Proposed Temporary Warehouse (excluding Dangerous Goods Godown) with Ancillary Facilities for a Period of 3 Years and Filling of Land in "Residential (Group D)" Zone, Lots 14 S.B RP, 15 S.B RP, 16, 17, 18, 19 RP and 20 S.B RP (Part) in D.D. 111, Pat Heung, Yuen Long (Planning Application No. A/YL-PH/967)

Compliance with Approval Condition (e) - Submission of a Drainage Proposal

Appendix I – Response to comments of the Chief Engineer/Mainland North, Drainage Services Department (CE/MN, DSD)

DRAINAGE PROPOSAL
(FOR APPROVAL CONDITON (c) UNDER
PLANNING APPLICTION NO. A/YL-PH/967)

REV	DESCRIPTION	DATE
DRAWING TITLE PROPOSED DRAINAGE SYSTEM		
DRAWING NUMBER FIGURE 3

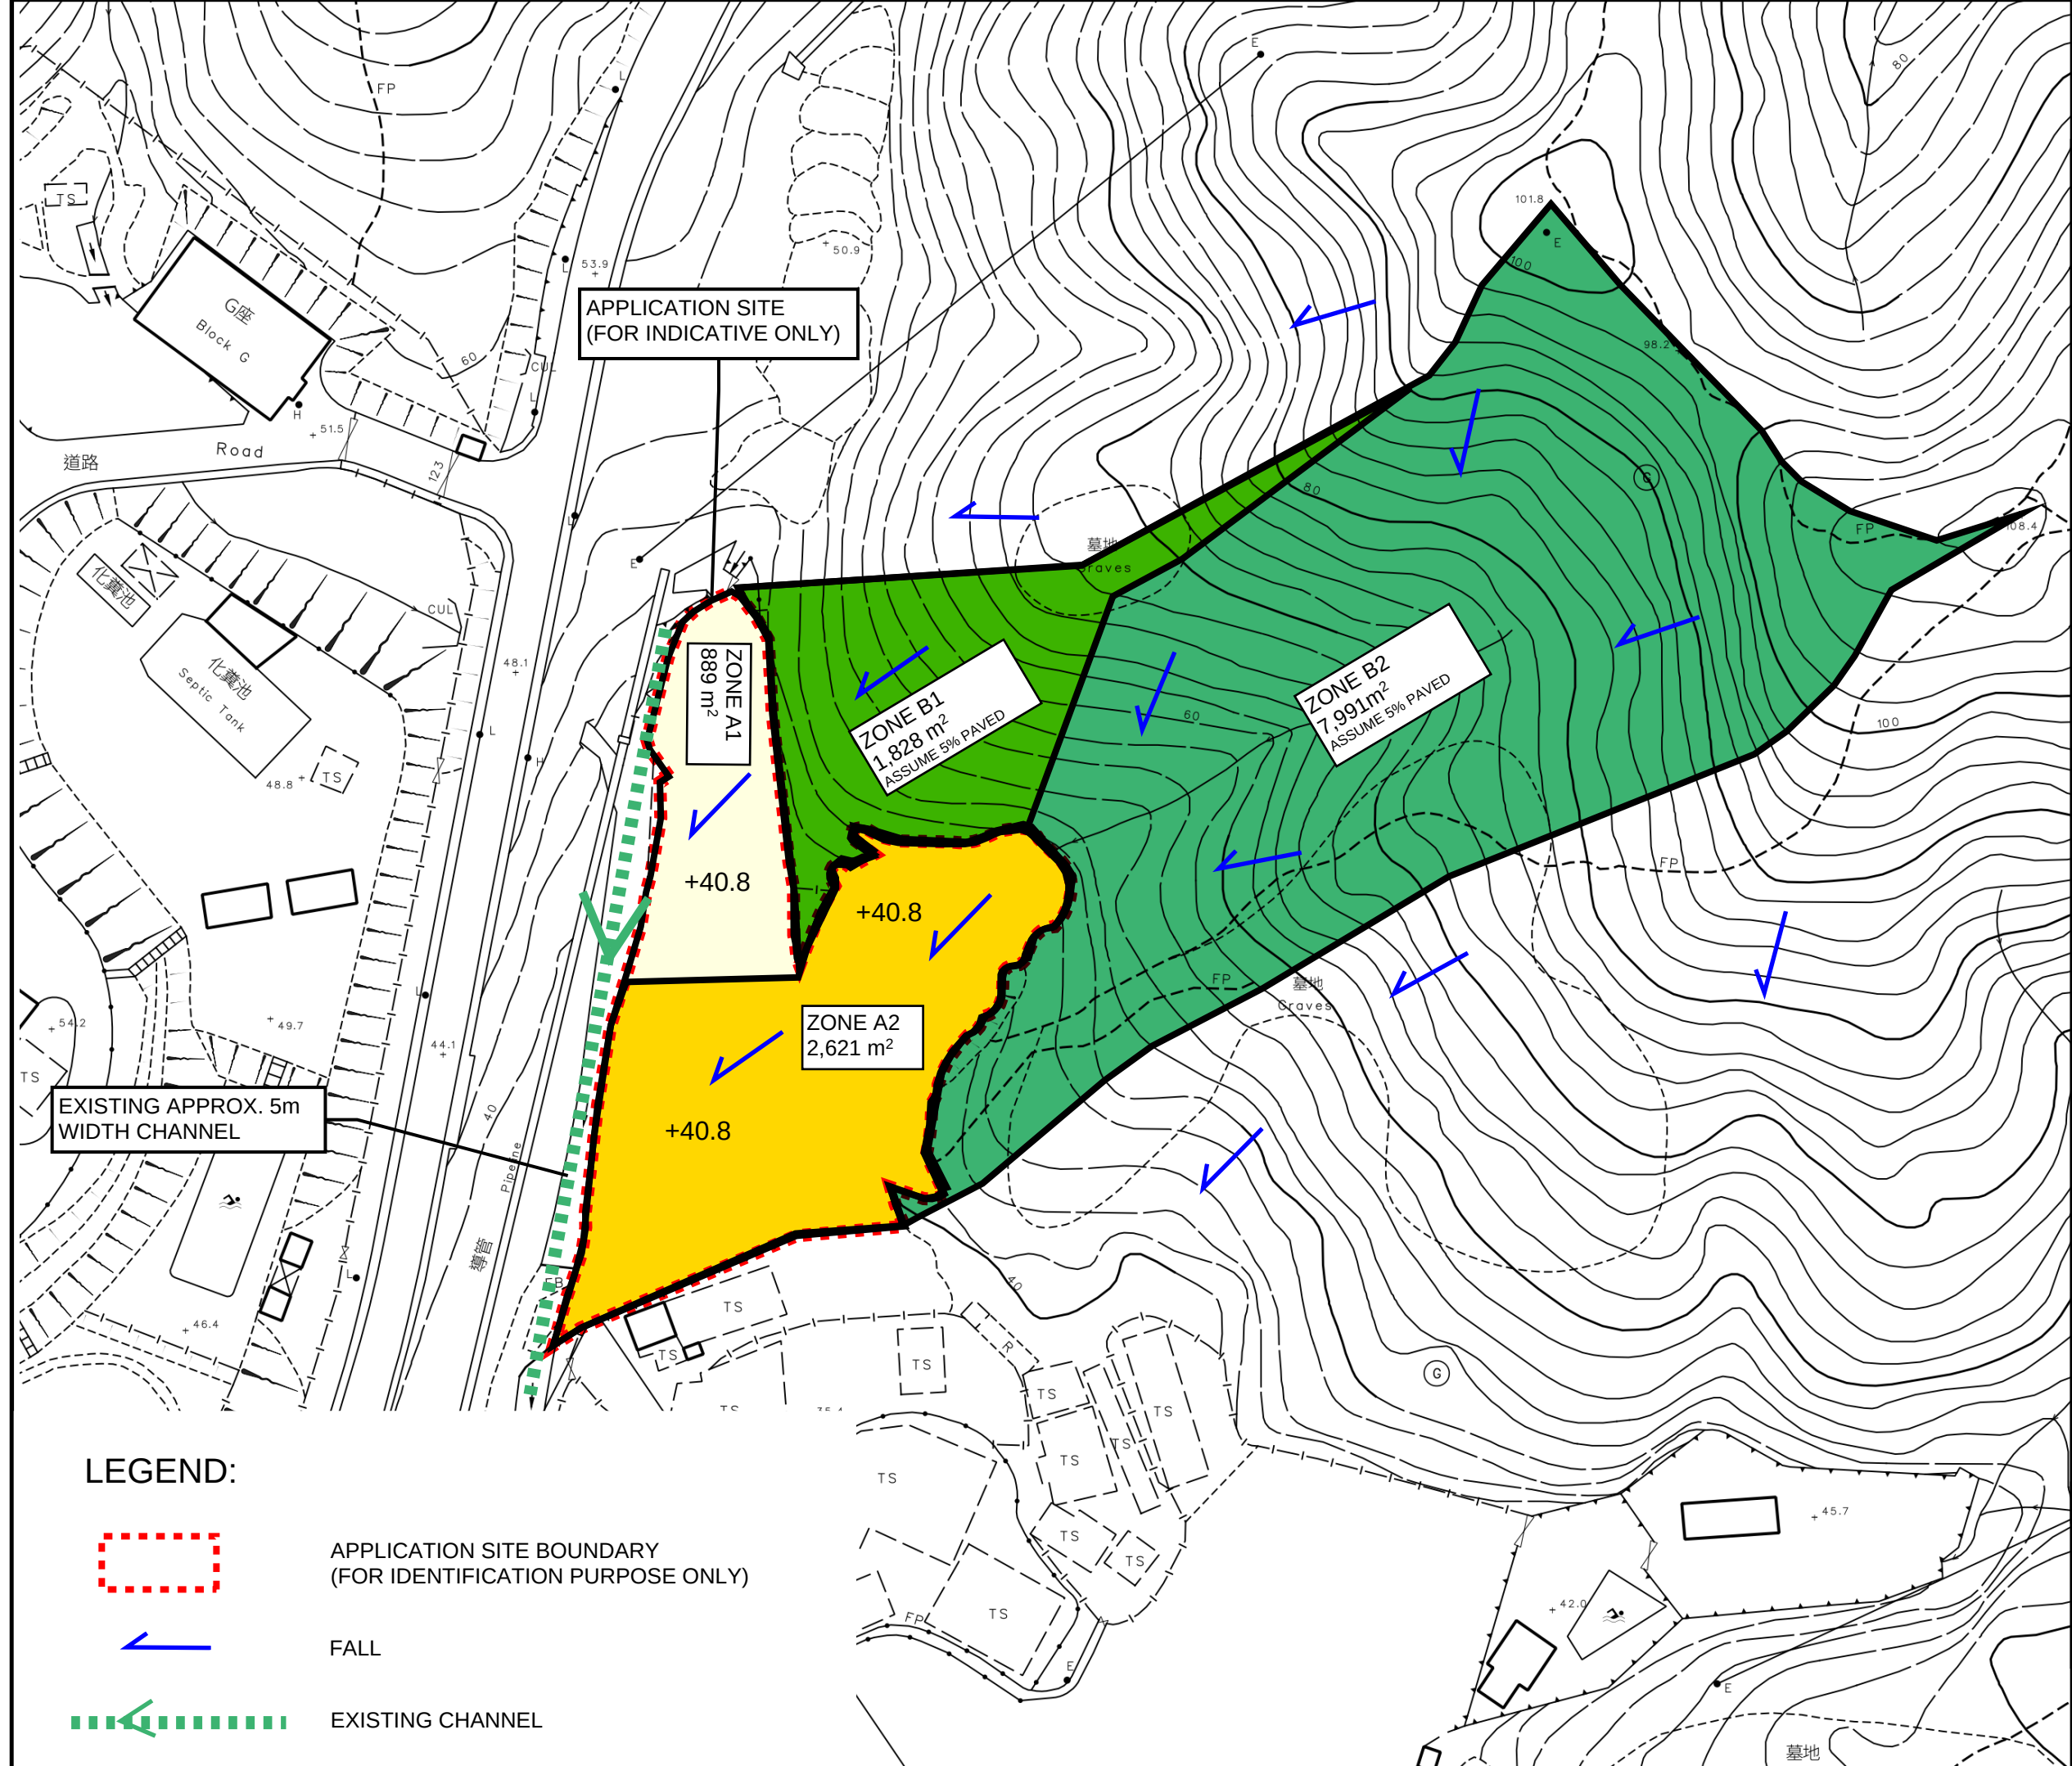
Comments of the CE/MN, DSD (Contact Person: Mr. Kenneth CHAN; Tel. No.: 2300 1259)		
(a)	The details of drainage schedule are not tally with the drainage details shown in figure 3.	Noted. The schedule and Figure 3 are updated (Appendix II).

(b)	CP1 .6 is missing from figure 3.	Please note the last catchpit before the discharge point should be CP2.8 instead of CP 1.6. The schedule and Figure 3 are updated accordingly (Appendix II).

(c)	Please confirm the last catchpit at the southern discharge point is CP1.6 or CP2.8 and rectify the details in figure 3 as necessary.	The schedule and Figure 3 are updated accordingly. Please note the last catchpit before the discharge point is CP2.8 (Appendix II).

(d)	The I.L. for CP2.6 in figure 3 is incorrect.	Noted. The typo is updated. IL of CP 2.6 is 39.77.
(e)	Please indicate the C.L. at discharge points in connection details A. Please also show the bottom level of the existing approx. 5m width channel at the proposed discharge points in connection details A.	Noted. Please refer to updated Figure 3 (Appendix II).
